PARK CITY MUNICIPAL CORPORATION
ADMINISTRATIVE PUBLIC MEETING MINUTES
PLANNING DEPARTMENT
<https://us02web.zoom.us/j/88167820277>
March 20, 2025

91 King Road – Historic District Design Review – PL-24-06328 – The Applicant Proposes to Construct a New Single-Family Dwelling in the Historic Residential - Low Zoning District.

Ridge Avenue dedication highlighted in red as recorded on the 91 & 95 King Road Plat.

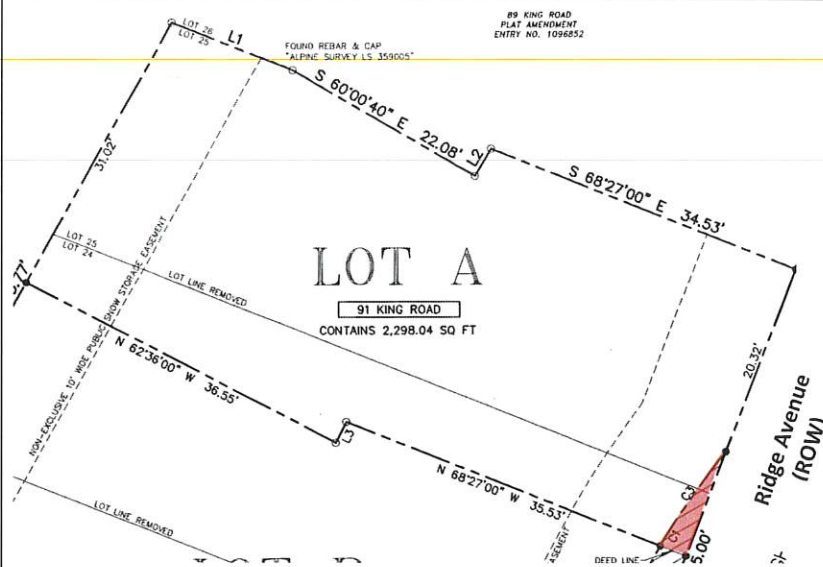
While the Applicant's plans do not show the Setback in the correct location, the proposed plan does comply with the 10-foot Front Setback requirement and exceptions outlined below.

LMC § 15-2.1-3(G)(1) states the Front Setback must be open and free of any Structure except: "Fences, walls, and retaining walls not more than four feet (4') in height, or as permitted in Section 15-4-2 Fences and Retaining Walls." The Applicant proposes a retaining wall that does not exceed three feet in height in the Front Setback and is compliant.

driveways, allowed Parking Areas and sidewalks, may be Hard-Surfaced or graveled.” The proposed hot tub and patio are in the Front Setback and are not allowed exceptions and must be removed from the plans (see Condition of Approval 19).
Side Setbacks for Lots up to 37.5 feet in width – 3’ each ³	Complies: 3’ LMC § 15-2.1-3(J)(7) states the Side Setback must be open and free of any Structure except: “ Fences, walls, and retaining walls as permitted in Section 15-4-2 Fences and Retaining Walls.” LMC § 15-4-2(A) states, “Fences and retaining walls shall not exceed six feet (6’) in height measured from Final Grade within any required Rear Setback or Side Setback.” The Applicant proposes several retaining walls that do not exceed six feet in height in the Side Setbacks and are compliant. Pursuant to the SSCUP approval Conditions of Approval 15 and 17, any modifications or additional retaining walls must return to the Planning Commission for review (see Exhibit E).

19. The Applicant shall update the final plans to show the Front Setback complies with Ridge Avenue Right-of-Way according to the LMC § 15-15-1 definition of *Setback*. The plans shall also be updated to comply with Front Setback regulations outlines in LMC § 15-2.21-3(G).
